9.2 NO. 12 (LOTS: 69 AND 80; PLAN: 4576) BROOKMAN STREET, PERTH - ALTERATIONS AND ADDITIONS TO SINGLE HOUSE SECTION 31 RECONSIDERATION

That Council, in accordance with Section 31 of the *State Administrative Tribunal Act 2004*, SETS ASIDE its decision dated 16 May 2023 and SUBSTITUTES its new decision to, in accordance with the provisions of the City of Vincent Local Planning Scheme No. 2 and the Metropolitan Region Scheme, APPROVE the application for Alterations and Additions to Single House at No. 12 (Lots: 69 and 80; P: 4576) Brookman Street, Perth in accordance with the plans shown in Attachment 2 with the associated determination advice notes in Attachment 9, subject to the following conditions:

Figure 1: Shadow Reduction Between Plans

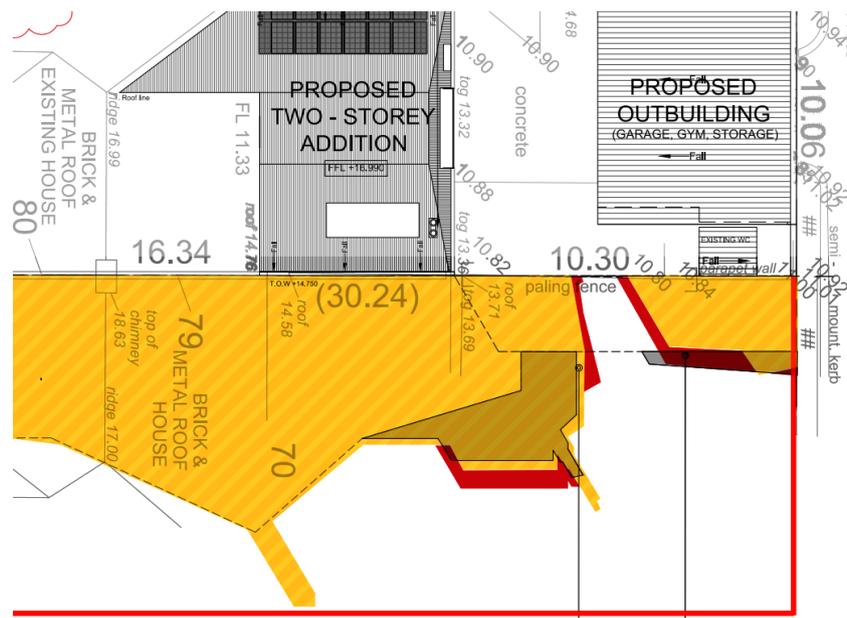
A comparison of the proposed overshadowing, and the overshadowing previously proposed as considered by Council is shown in the **Figure 1** below. The area highlighted in orange represents the portion of the adjoining property that would be overshadowed by the proposed development in the amended plans, measured in accordance with the R Codes at midday on 21 June with the shadow extending to the south, which is when the sun is lowest in the sky and overshadowing is at its worst.

Areas highlighted in red represent areas that would have been overshadowed as a result of the refused plans but would no longer be overshadowed due to the amendments to the plans made. The red line shows the adjoining property’s lot boundary.

The overall proposed overshadowing of No. 10 Brookman Street has decreased from 126.7 square metres (41.7 percent) in the refused proposal, to 121.4 square metres (39.9 percent).

PROPOSED LANDSCAPE PLAN

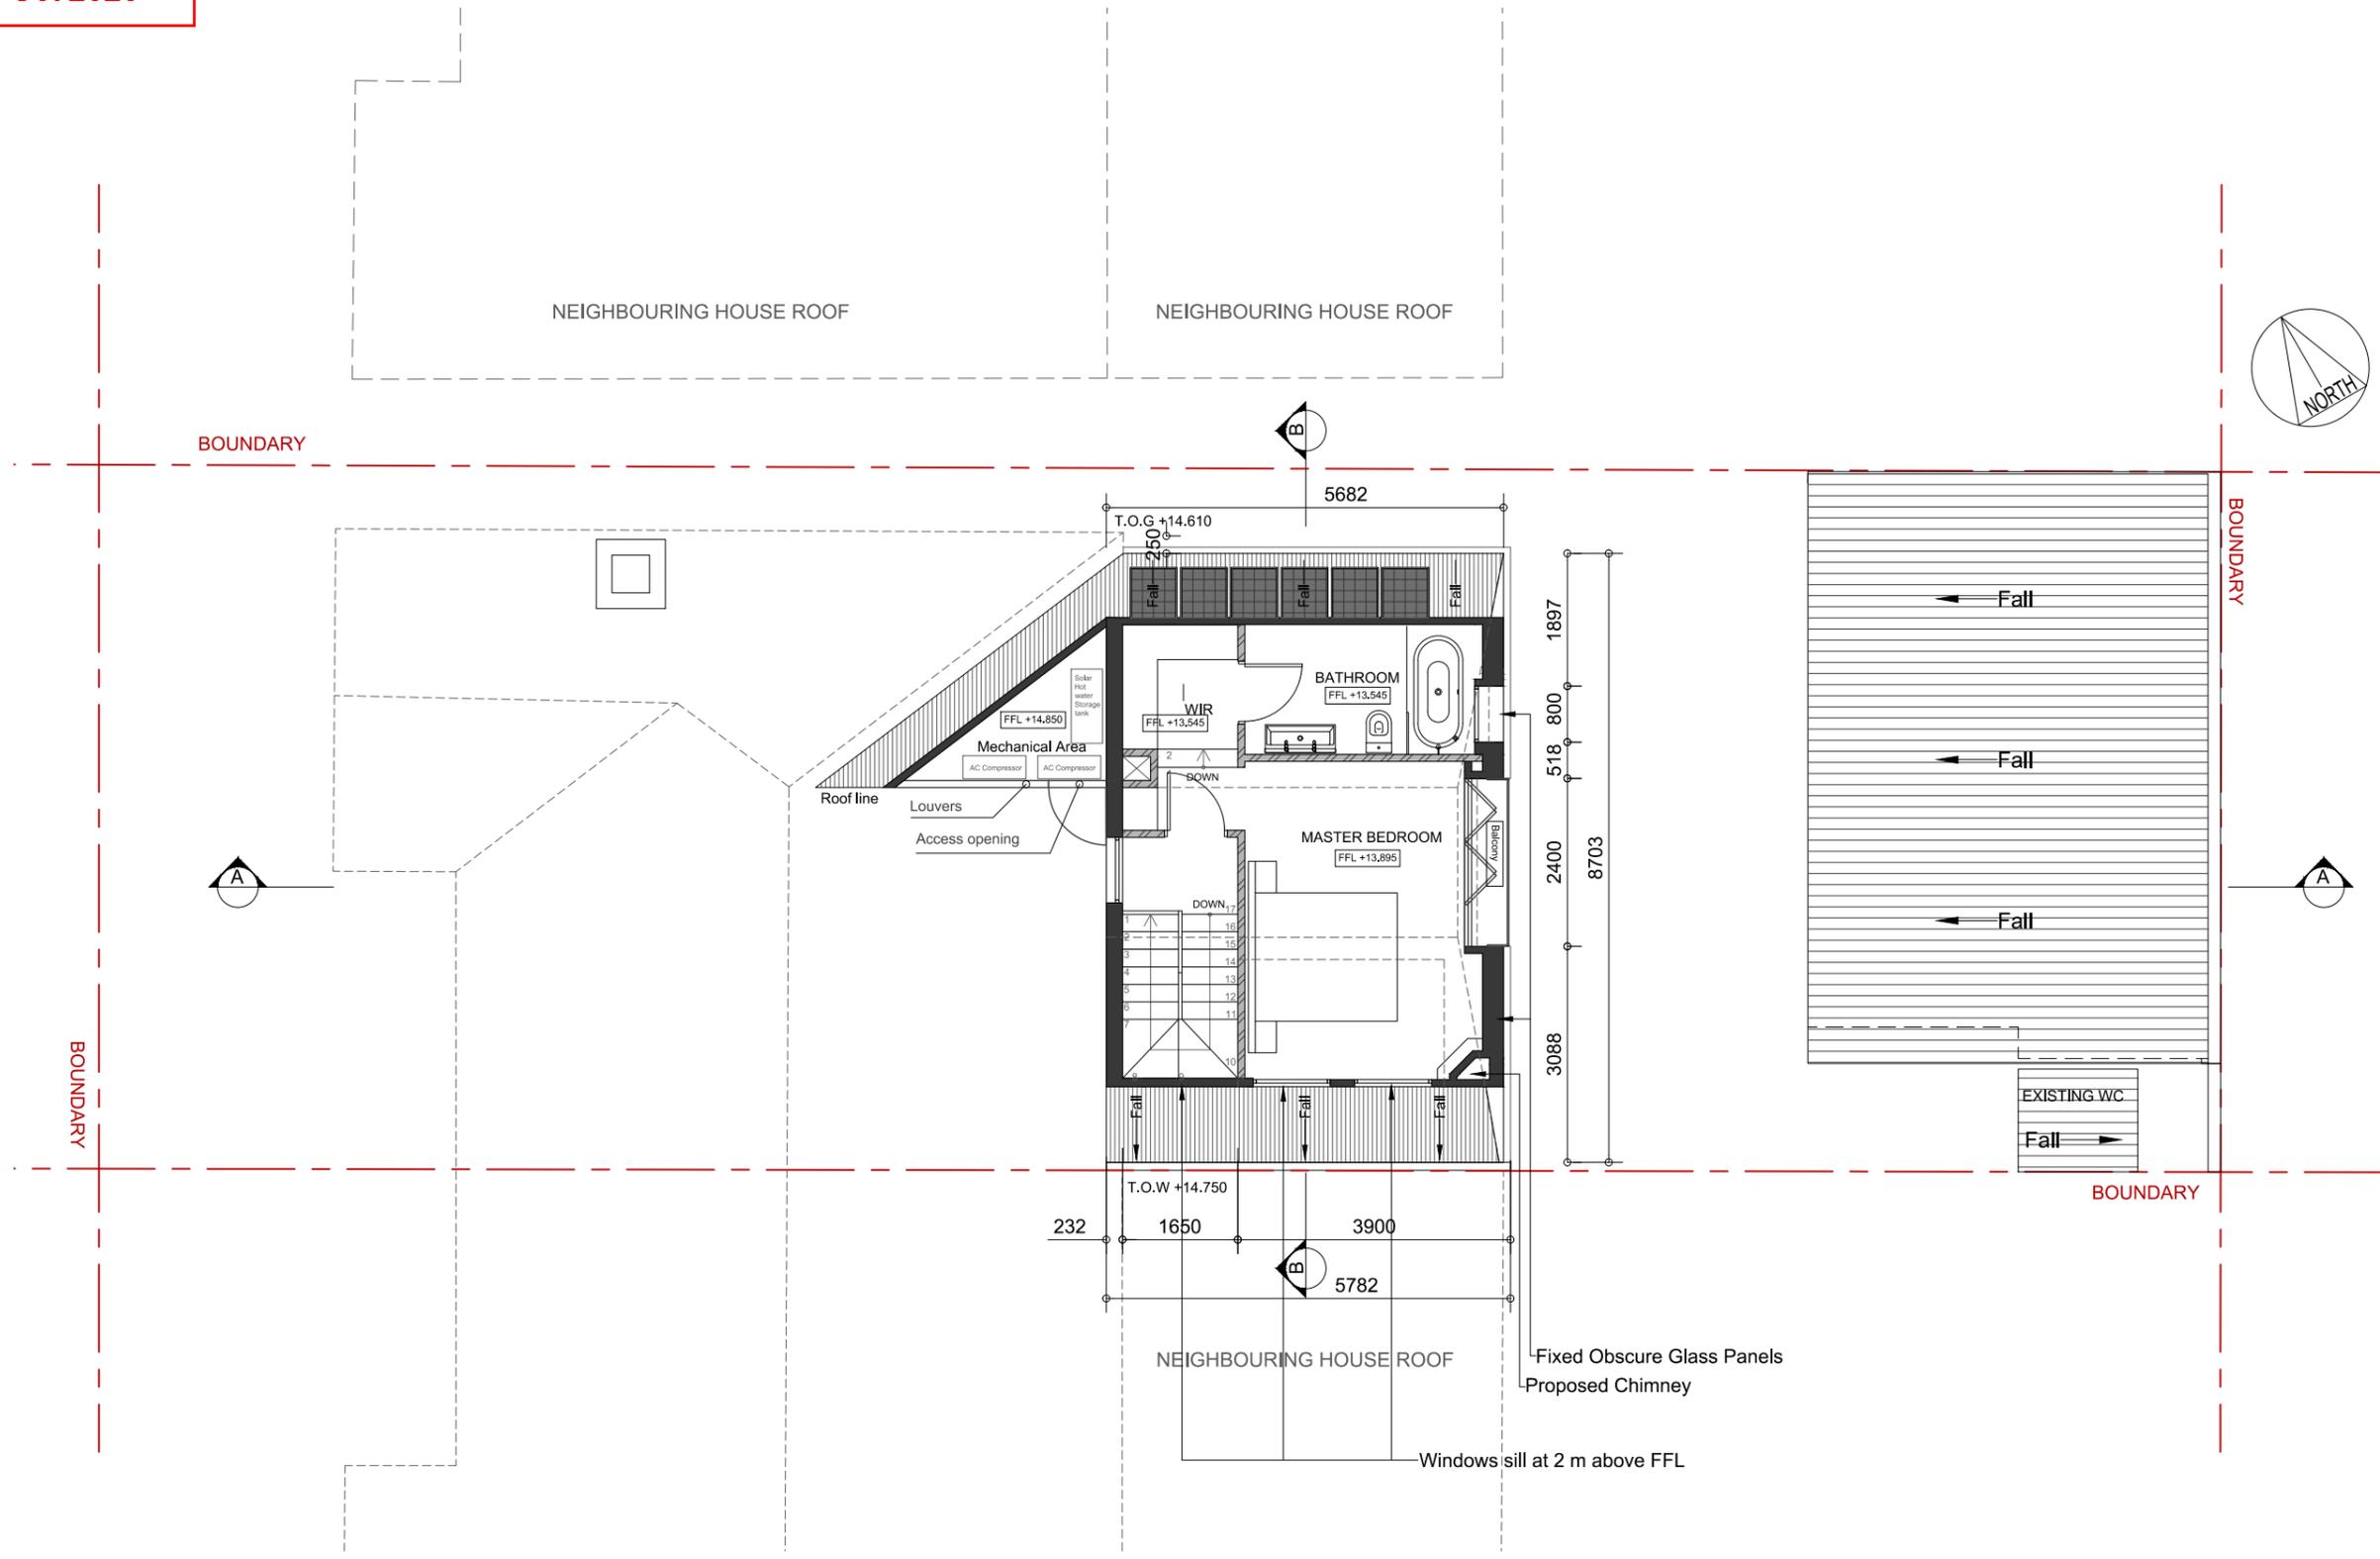
- The landscaping plan does not provide sufficient information to confirm the landscaping to the rear of the dwelling would support high levels of occupant amenity;
- The design approach to fully enclose the existing WC structure and to line the structure with timber would not respect or value the existing structure. The external location of the WC forms part of the heritage value of the structure and as such it should be expressed externally and retain its materiality; and
- The solar panels and EV charger shown on the plans are supported. However, insufficient information has been provided on the environmental sustainability measures proposed, to provide DRP support for this element.

- There are no obvious changes to the Landscape Plan or further detail provided for assessment. Whilst this is relatively simple landscape proposal further detail would be needed to confirm a high quality landscaping outcome on-site. The provision of further detail could be conditioned, noting the amendments undertaken in other aspects of the proposal.

- Areas to be irrigated or reticulated;
- The location and type of proposed plants including the provision of a minimum of one tree on the subject site within the deep soil area; and
